## **DEVELOPMENT and PLANNING SERVICES COMMITTEE**

**June 19, 2017**

*Development Services Department Memorandum*

SUBJECT: Development Permit No. 412 (Form and Character – Multi-Family)  
 Legal: Lot 2, Section 13, Township 20, Range 10, W6M, KDYD, Plan 13746  
 Civic Addresses: 1151 – 8 Avenue NE  
 Owner/Applicant: Lakeshore Terrace Developments Ltd.

DRAWING TITLE:  
**UNITS 5-6**  
(SEMI-DETACHED)

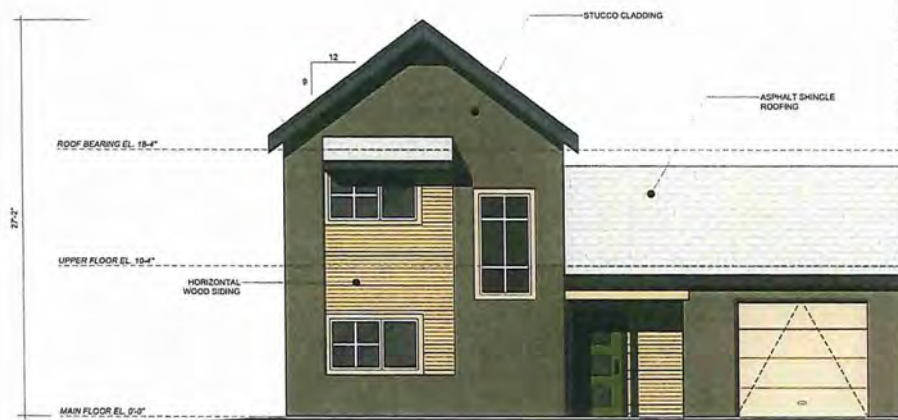
The DRP generally supported the proposal with the exception of the requested variance to reduce the minimum separation between units 5 and 6. It was suggested that combining the units into a duplex structure would be preferred, or alternatively if Council supported the variance, that the landscaping be adjusted to hard landscaping in place of plantings. It was suggested that the density of the landscaping could be reduced overall.

The second variance request is to reduce the minimum separation between residential buildings on the same lot of not more than one storey in height from 1.5 m to 1.1 m to accommodate units 5 and 6. The minimum separation requirement is generally based on BC Building Code and limiting distances for fire and safety. The buildings will be two storeys tall on the outside but drop down to one storey at the closest point where the variance is requested. Staff support the requested variance subject to meeting BC Building Code. Confirmation that the buildings will meet BC Building Code will be completed at the Building Permit stage.

Panel members discussed the proposal, noting the need for increased density. Questions were addressed regarding the building spacing, landscaping (noting it would be possible to feature less dense planting), parking and access. Panel members sought clarification on the requested variances, questioning the utility of the narrow space requested between units 5 and 6. The panel was not supportive of this variance regarding the separation between buildings 5 and 6.

- eliminating the variance regarding the separation between buildings 5 and 6.

The DRP would support a duplex as an option combining units 5 and 6. The DRP suggests that should Council support the requested variance, that the landscape plan be revised to include hard landscaping to be installed between buildings 5 and 6.
